## Groundwater Classification - Former Exide Technologies Facility, Frisco, Texas

COMMENTS ON APPENDIX 7 OF AFFECTED PROPERTY ASSESSMENT REPORT,  
FORMER OPERATING PLANT, FRISCO RECYCLING CENTER, FRISCO, COLLIN COUNTY,  
TEXAS (AGREED ORDER DOCKET NO. 2011-1712-IHW-E), PASTOR, BEHLING &  
WHEELER LLC, DATED 7/10/2013

12 SEPTEMBER 2013

**Figure 1**  
**Former Exide Technologies**

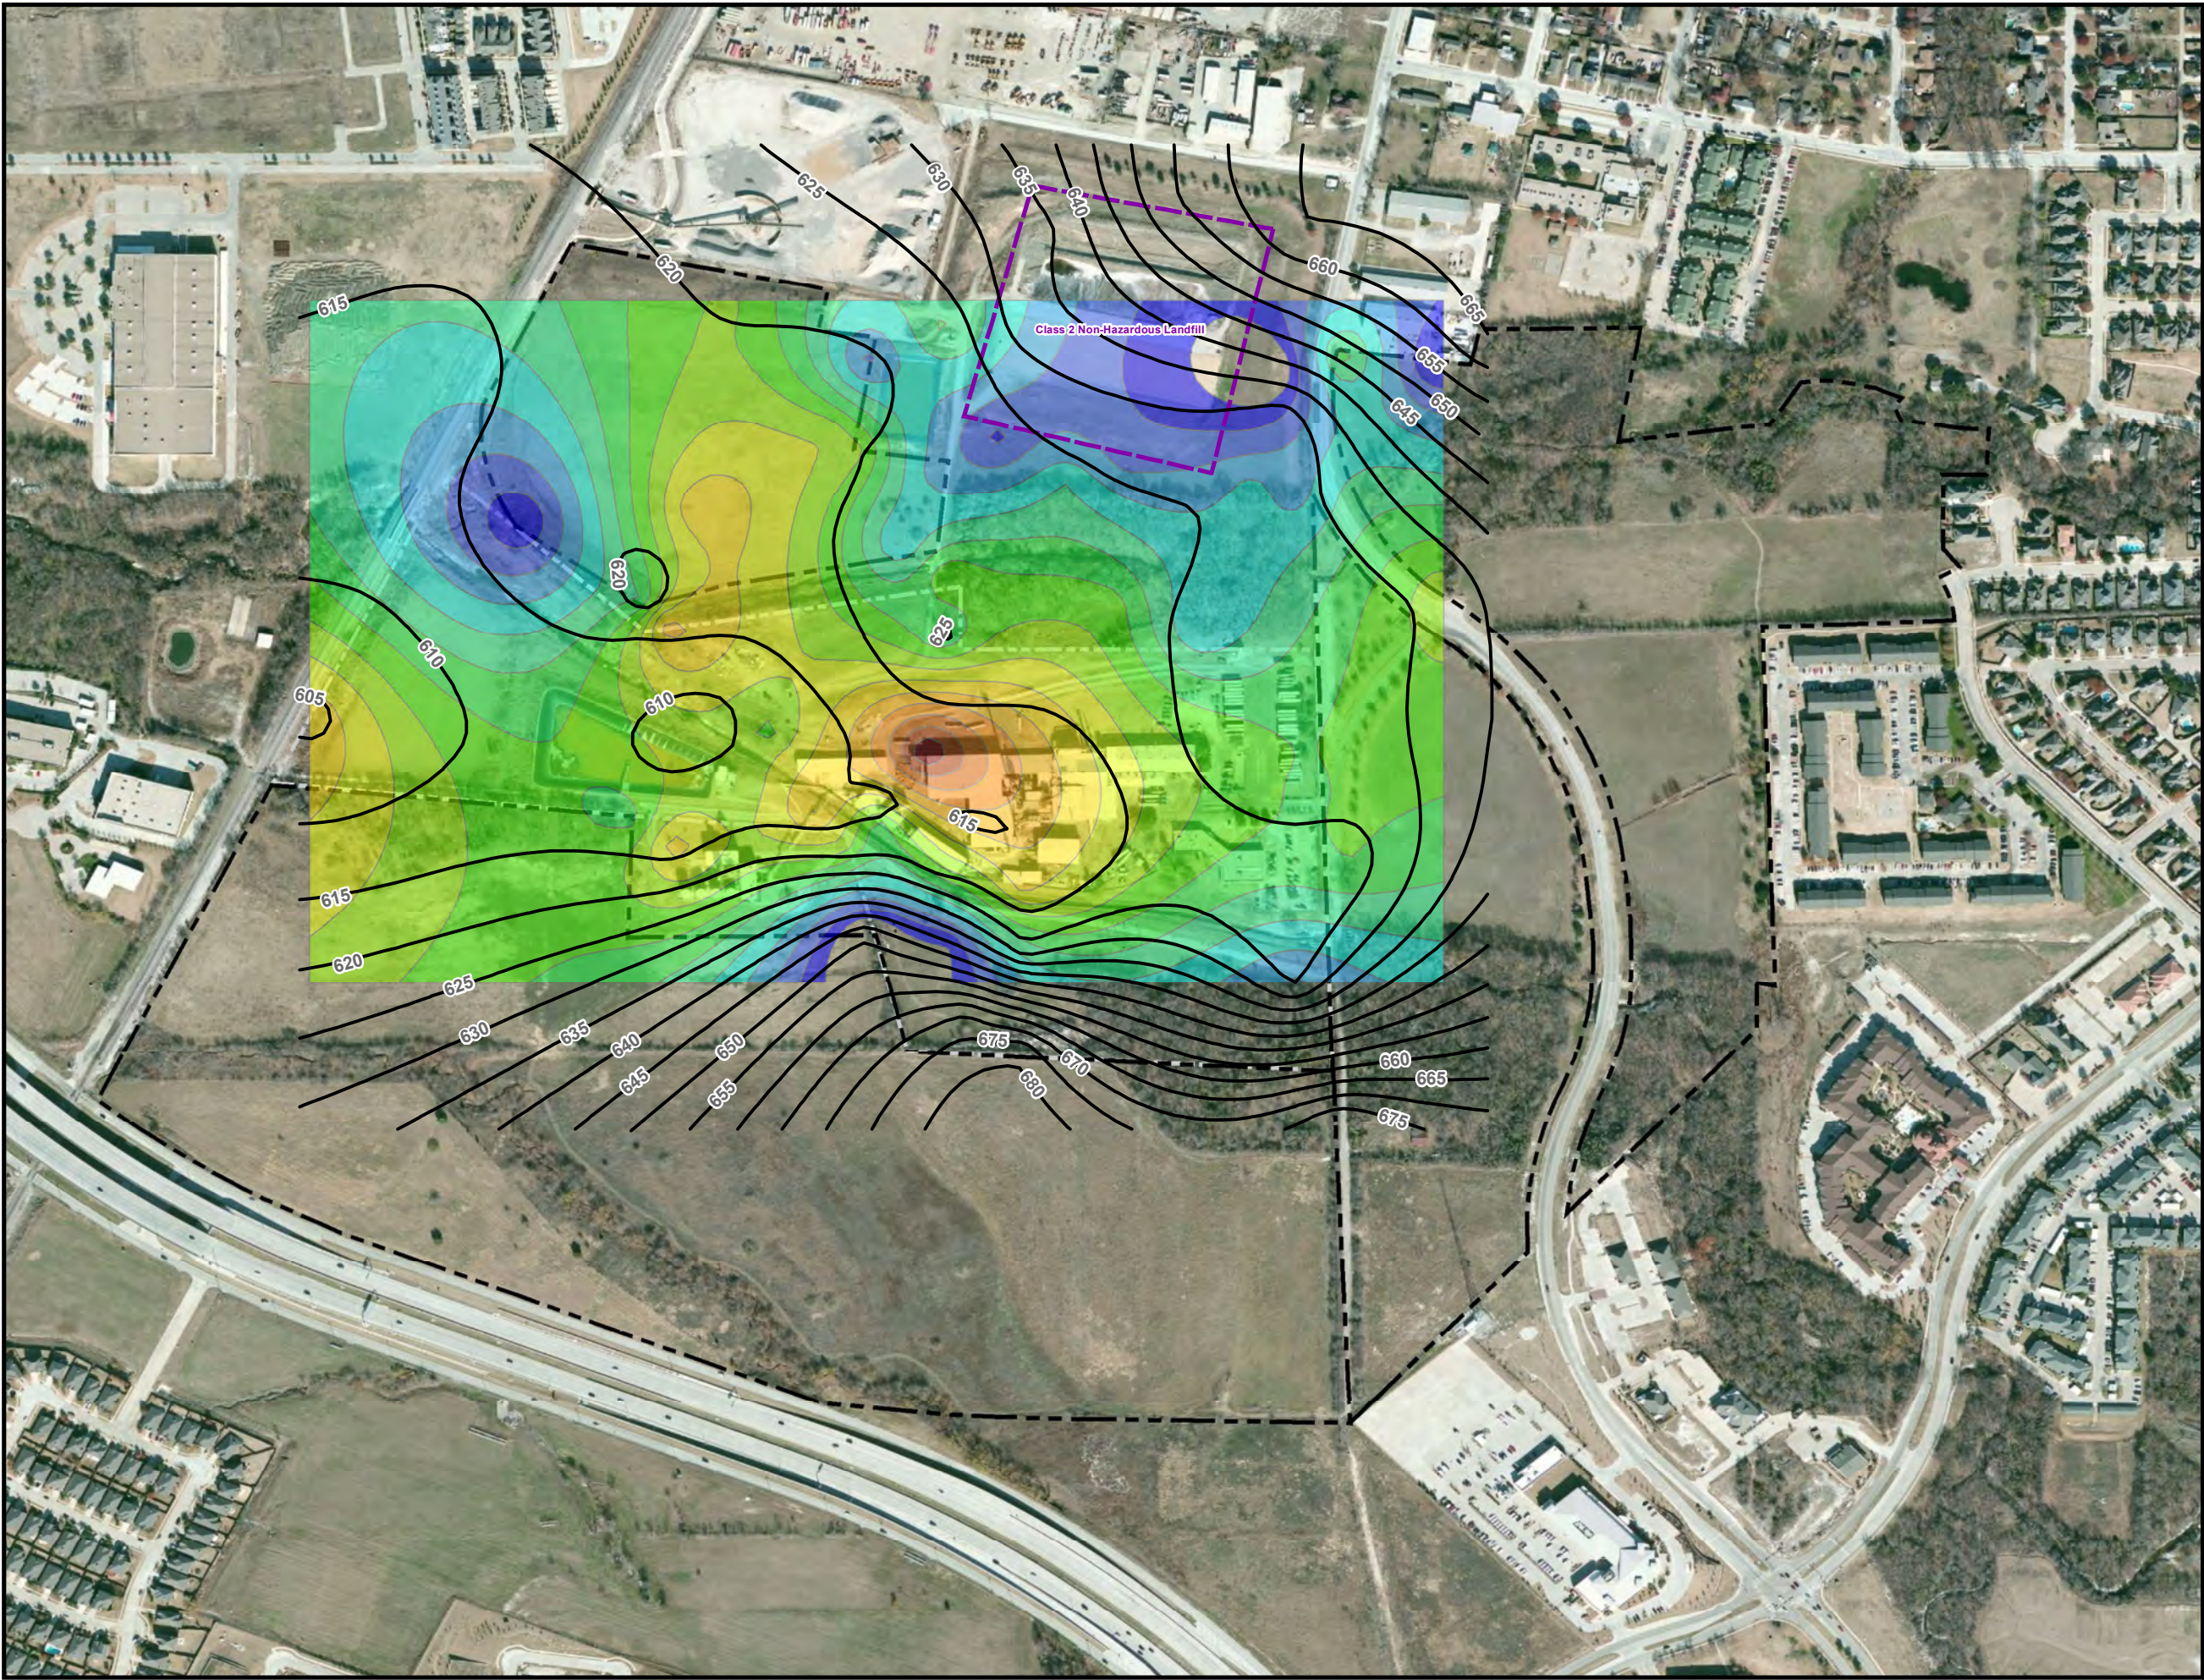
These alluvial deposits consist of unconsolidated soils with grain sizes ranging from silty clays to sandy gravels. This unit is present and is continuously saturated across the northern and eastern portions of the site. Figure 1 (attached) provides a map of the apparent extent of this unit based on an overlay of the extent of the clayey gravels and extent of the gravels and sands as mapped by PBW. Figure 2 documents the saturated thickness of the unit in and around the former Exide operating facility.

Figure 4  
Aerial Photograph  
1942

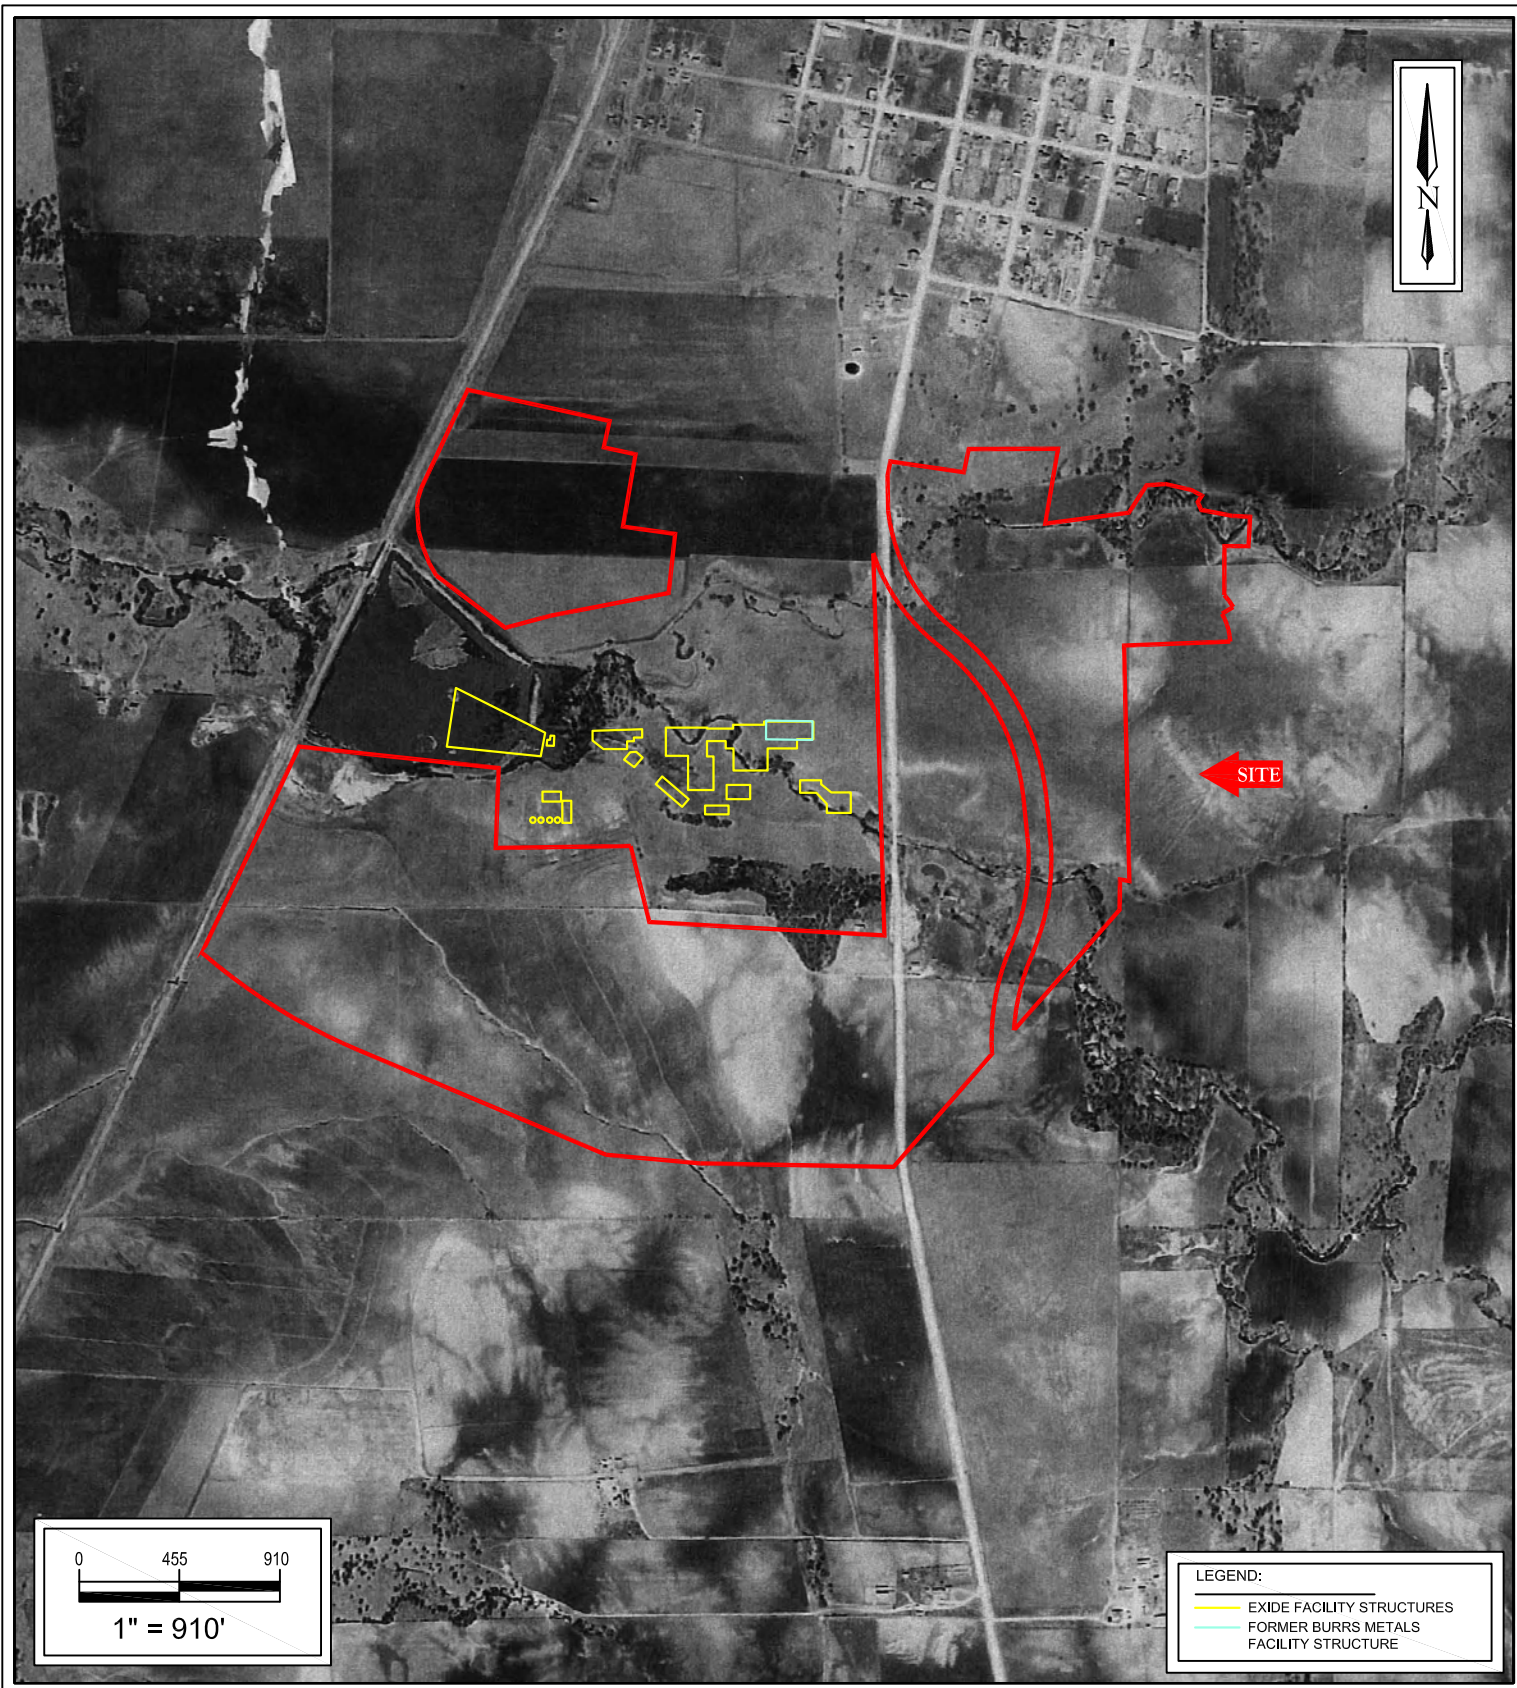
Because the Exide facility extends over the former channel of Stewart Creek and its northern tributary (the Slag Landfill and North Disposal Area extend over the northern tributary's former channel as well), a large percentage of the central and western portions of the operating facility is situated on fill. In some areas the fill is relatively deep and is saturated. For example, MW-30 was installed through (or very close to) the former Stewart Creek channel. The boring log for MW-30 reports slag and lead were found at a depth of 28 feet below grade at that location. Figure 3 depicts the possible extent of fill at the former operating facility. The former stream channels are also depicted on Figures 1-3, and an overlay of the Exide facility on a 1942 aerial photograph is provided as Figure 4.
